DEPARTMENT OF THE NAVY
CRANE DIVISION
NAVAL SURFACE WARFARE CENTER
300 HIGHWAY 36
CRANF., INDIANA 47512-5000

Enclosure (1)
Final Statement of Basis
for
Dye Burial Grounds
Solid Waste Management Unit 02

Enclosure (2)
Responses to the November 10, 2005 U. S. EPA Comments
on the
Draft Statement of Basis
for the
Dye Burial Grounds
Solid Waste Management Unit 02

**FINAL RESPONSES TO UNITED STATES ENVIRONMENTAL PROTECTION AGENCY COMMENTS
(DATED 10 NOVEMBER 2005) CONCERNING THE STATEMENT OF BASIS (DATED AUGUST, 2005)
FOR NAVAL SURFACE WARFARE CENTER CRANE SOLID WASTE MANAGEMENT UNIT #02/11
(DECEMBER 01, 2005)**

Figure 4: DBG Boundary and Trenches

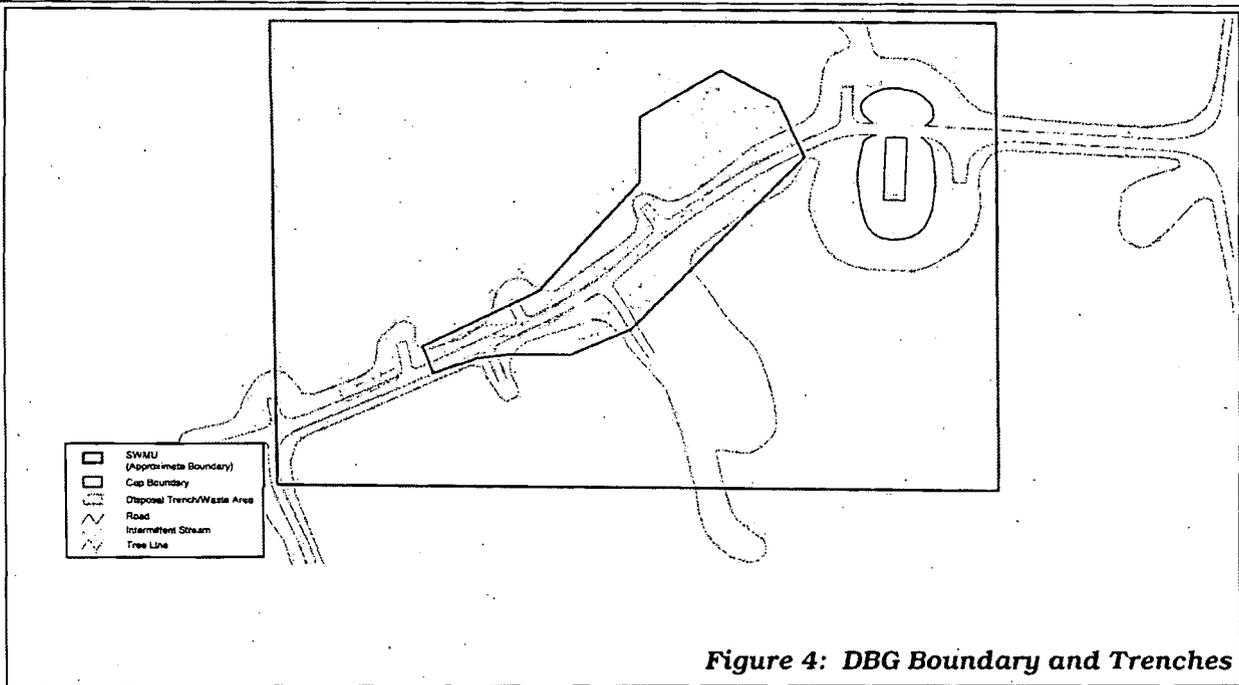
2) Page 4 states that Figure 4 depicts the burial trench locations relative the capped area, but I can't see them on my copy.

Figure 4 has been enlarged to make the burial trenches, and the legend identifying them, easier to see and read, respectively.
